Gatwick Airport Northern Runway Project

Examination Ref: TR020005

Joint Local Authorities Response to the Applicants Deadline 6 Submissions

Deadline 7: 15 July 2024

Figure 7: Percentage of respondents calculated as highly sleep disturbed as a function of the average summer night additional aircraft noise-induced awakenings (N=1,483)

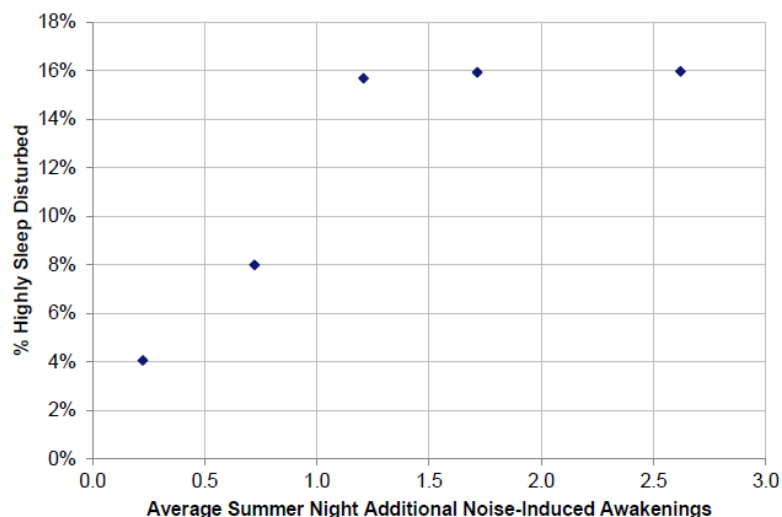
- 15.23 It is agreed that for some individuals the existence of a potential additional noise induced awakening may not be significant. But as the results below show (Figure 7 from CAP2251), around 12% experiencing one additional awakening are highly annoyed, which is a significant adverse effect, and it is likely that a greater proportion would be annoyed, which is an adverse effect. Policy requires that, not only must significant adverse effects be avoided but that reasonable steps must also be taken to mitigate and minimise such adverse effects.

- 15.24 It would, therefore, be inconsistent to offer sound insulation to households living within contour bands even though there may be some individuals who are not significantly adversely affected, and not to offer such mitigation for those likely to experience an average of one additional noise induced awakening simply because not everyone within that contour is likely to experience that significant adverse impact.
